SUBJECT: IDENTIFICATION AND CONVERSION MODEL V3 OF ZCB BOARD UNITS AFFECTED: ALL SYSTEMS	V3-0022
	DATE: 1 DEC. 1981 PAGE: 1 OF 4

CONDITION: Identification of the different versions of the ZCB PCB.

REV 3 ZCB

PRODUCT IMPROVEMENT BULLETIN

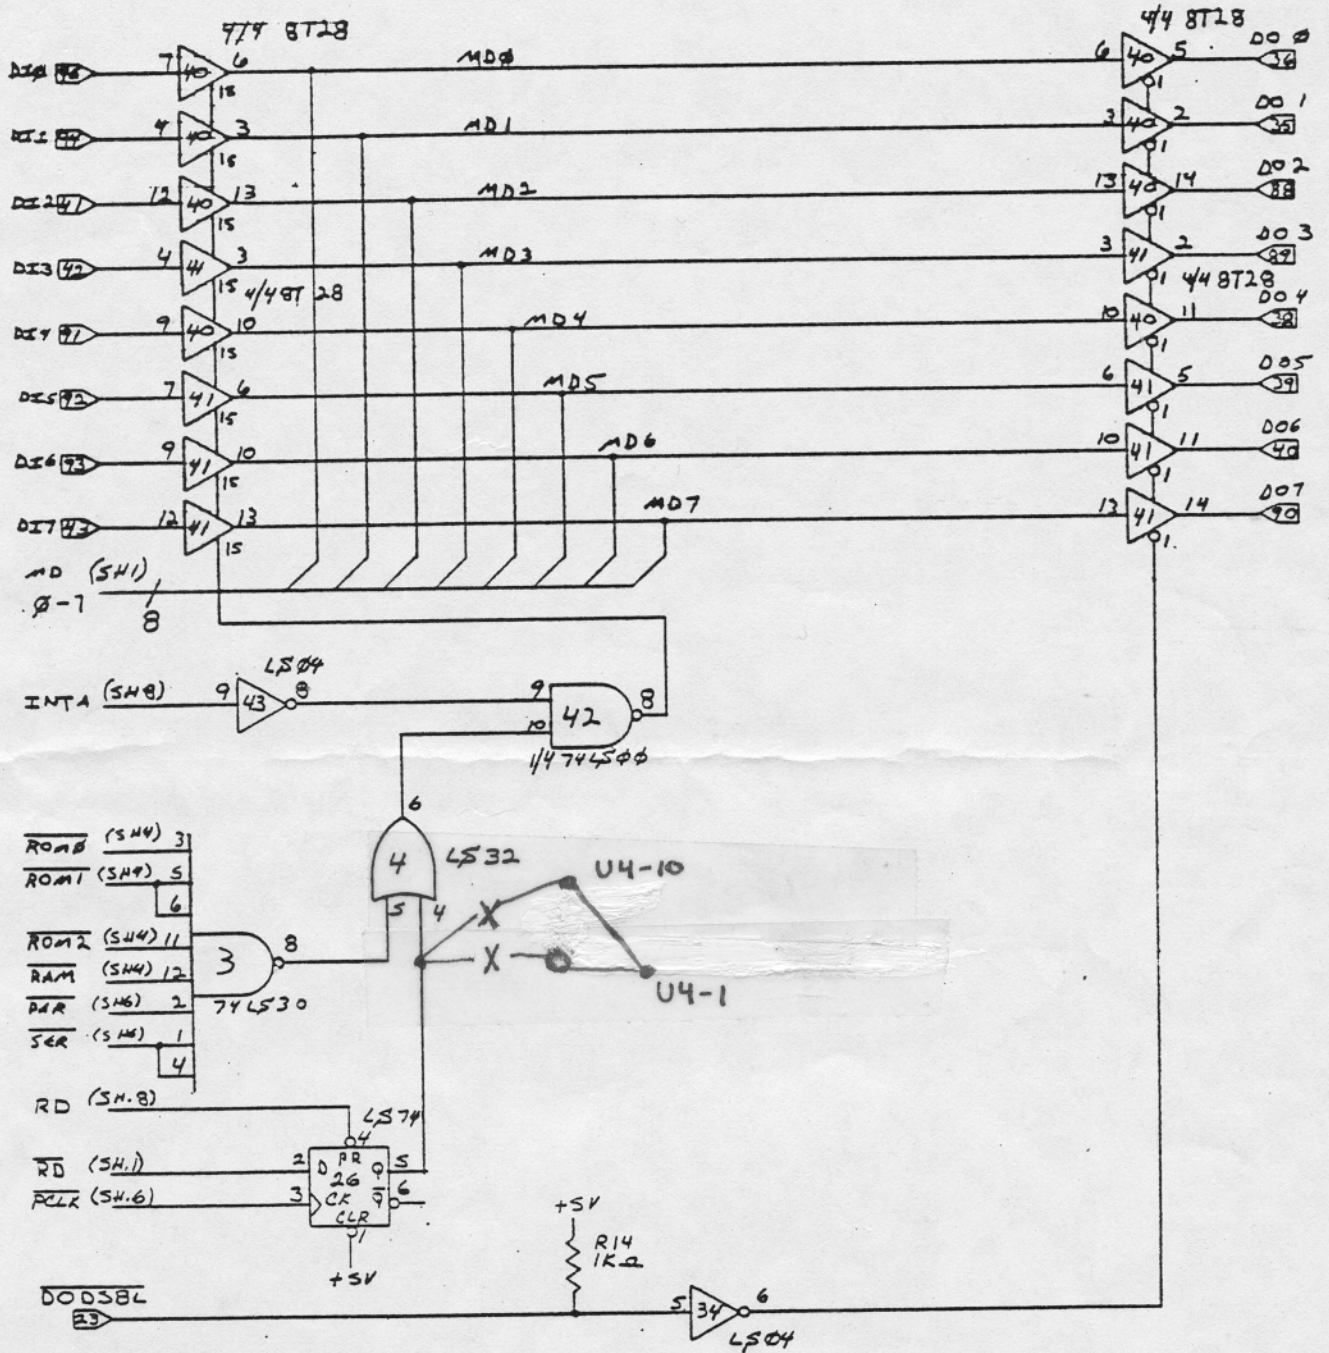
The Revision 3 ZCB board is now in production at Vector. This Revision was implemented in order to delay the RD signal, which was creating a race condition that caused a data glitch. This "glitch" could create memory errors that were attributed to the 64K PCB. This revision is a factory only modification. The error condition is apparent when a 64K PCB is swapped or the LS244's are changed to resolve a memory error, but the original 64K PCB functions properly with a different ZCB board. The attached schematic should be added to your ZCB documentation.

U26-1	to	U26-14
U26-2	to	U33-9
U26-3	to	U33-13
U26-4	to	U33-8
U26-5	to	U4-4
U4-1		U4-10
cut U4-4	to	U4-10
cut U4-4	to	feed-thru and U4-1
